SITE PLAN
SCALE: 1" = 20'

02-5-1229

of 1 sheet
 MEDICAL CLINIC
 8 TH HILLSIDE
 WICHITA

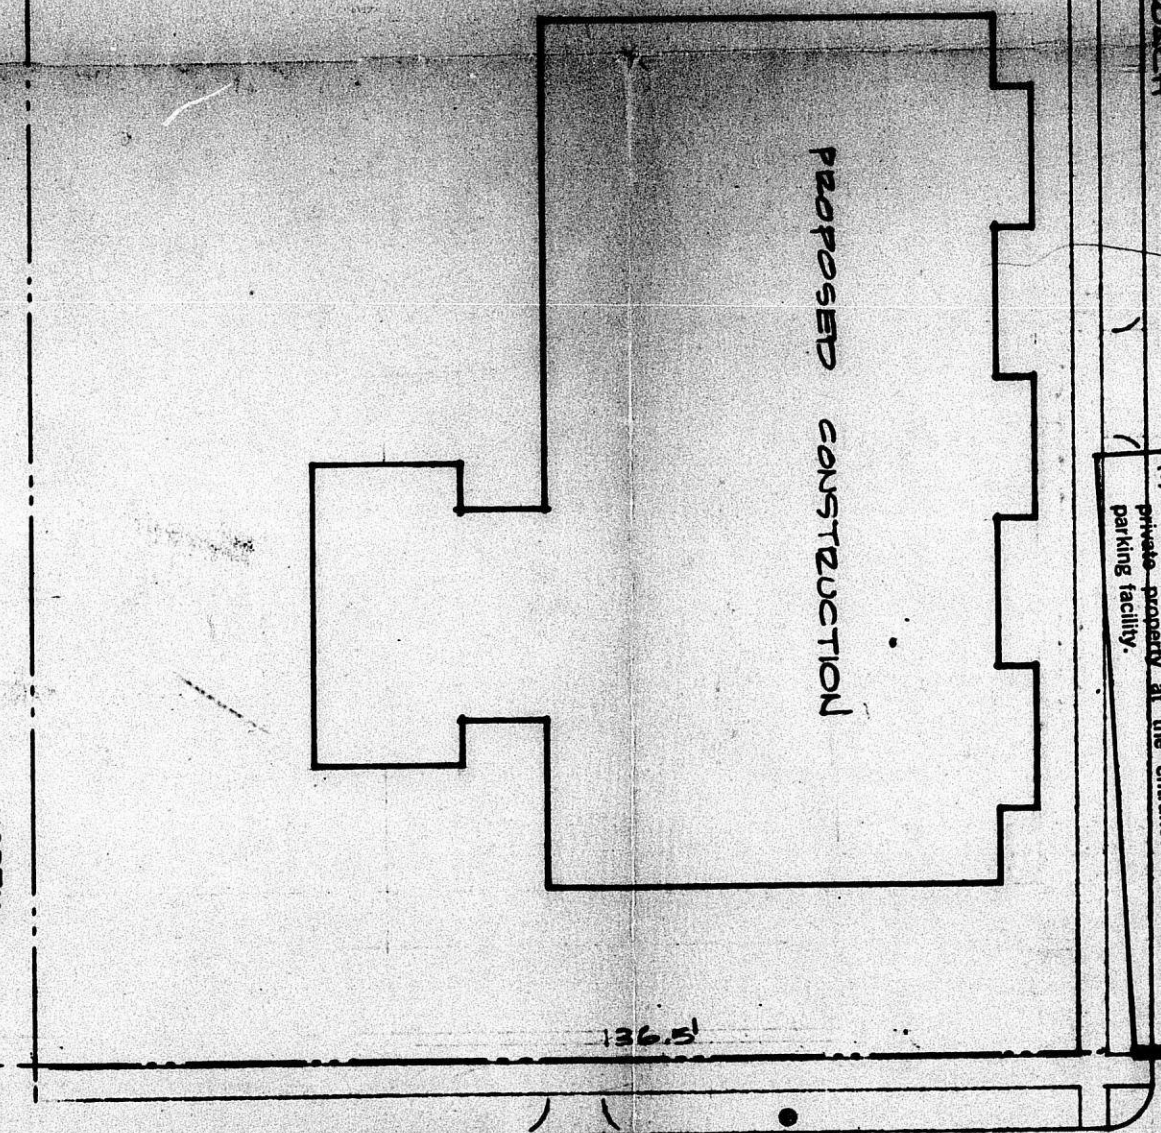
TRAFFIC-ENGINEERING DIVISION APPROVED
Date: 2-27-70
1/27/70
(A) Parking barriers shall be installed at all locations adjacent to public ways and shall have a minimum height of 42" and a minimum cross section of 4" x 4".
(B) Stall lines shall be painted and 4" or greater in width.
(C) Proper ingress and egress signs shall be installed and placed conspicuously at the entrance and exit of the parking facility.
